RE: **AURORA FOOD STORE**
 2000 ANAQUOD ROAD
 REGINA, SK
 Commission No. 2445

RE: Pharmacy Bulkhead

1.0 Fixture Plan

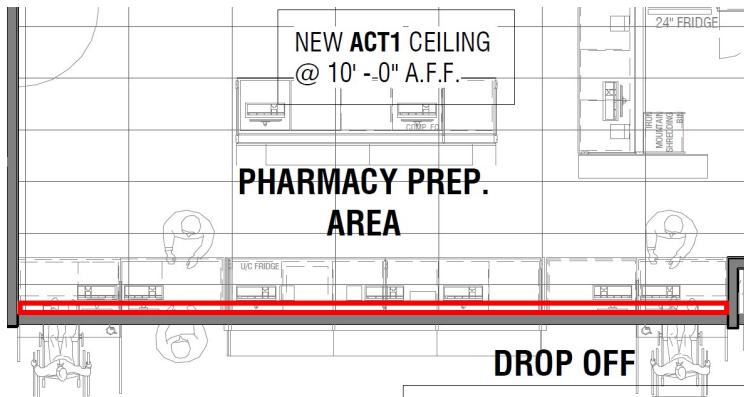
- .1 Modify location of security shutter and millwork to not be in line with the bulkhead:

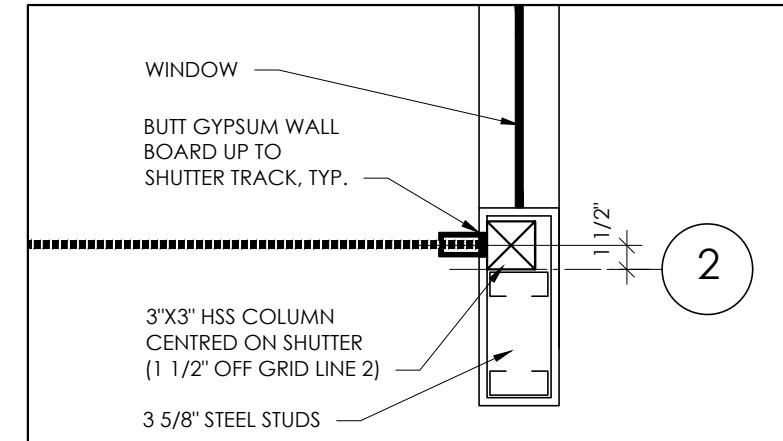
- .1 Refer to drawing F4.1 REFLECTED CEILING PLAN.
Provide 3" gap between T-Bar/ACT and Bulkhead for security grille:

AURORA PHARMACY SHUTTERS / MILLWORK - NOVEMBER 5, 2025

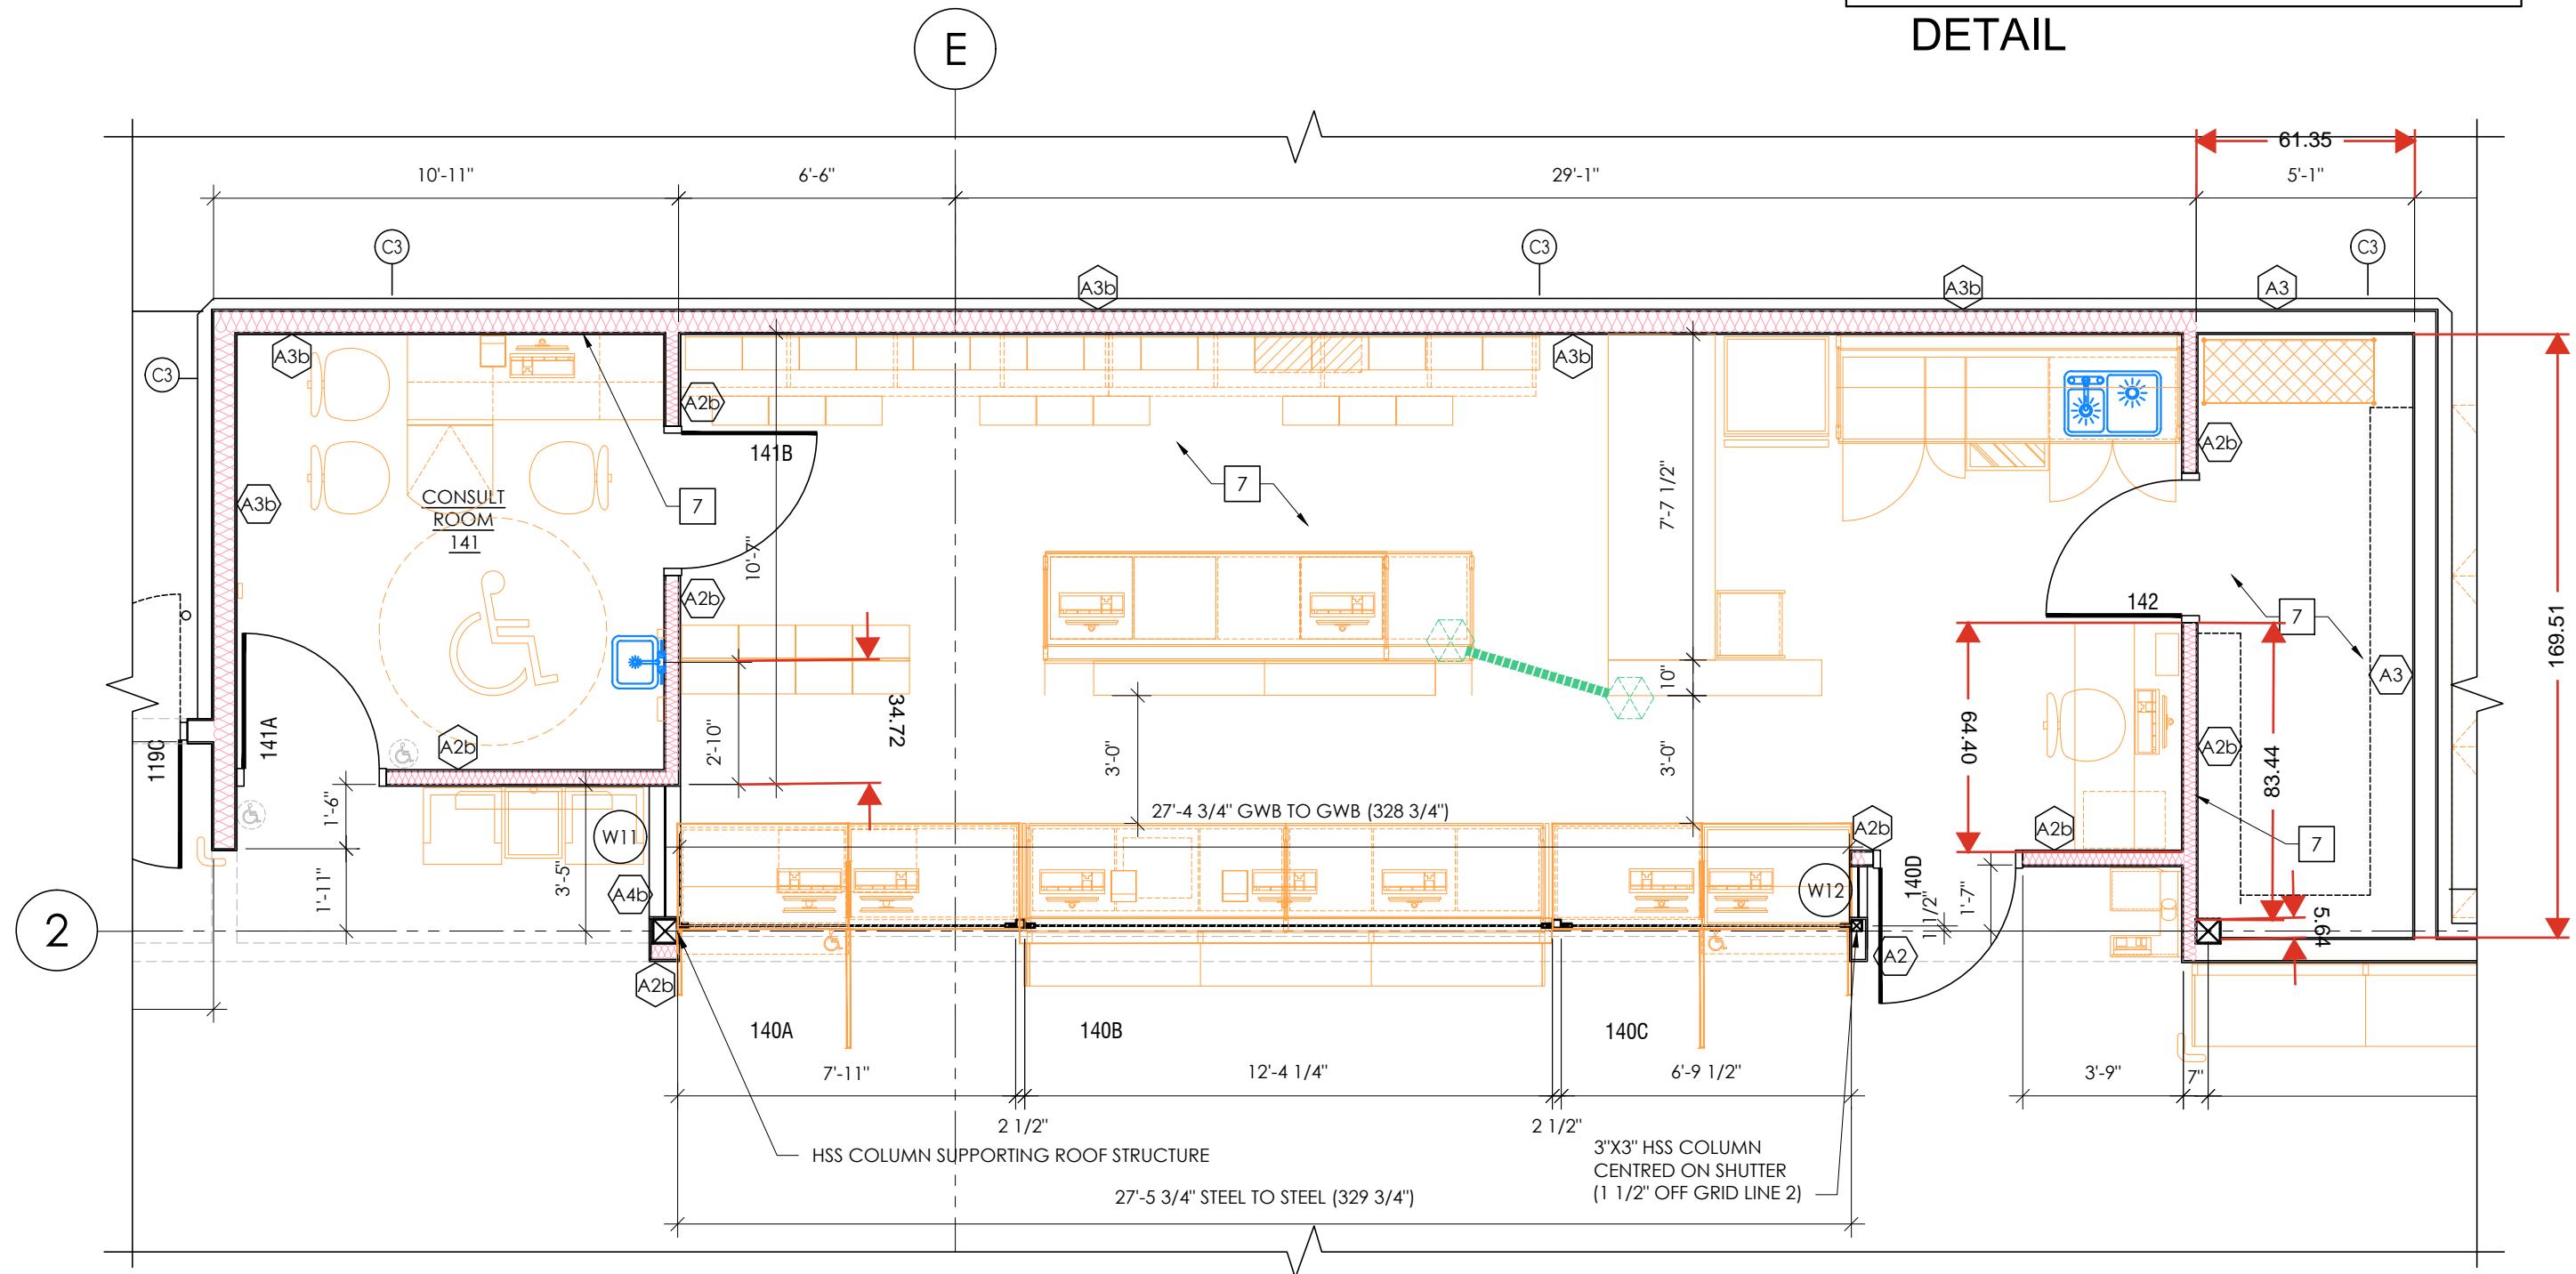
- .1 Modify plan layout as per attached dated November 5, 2025 (1 page).
.2 Modify #1/A7.3 SECTION @ PHARMACY as per attached dated November 5, 2025 (1 page).
Provide Axiom Classic Armstrong Ceiling Solutions trim at T-Bar opening.
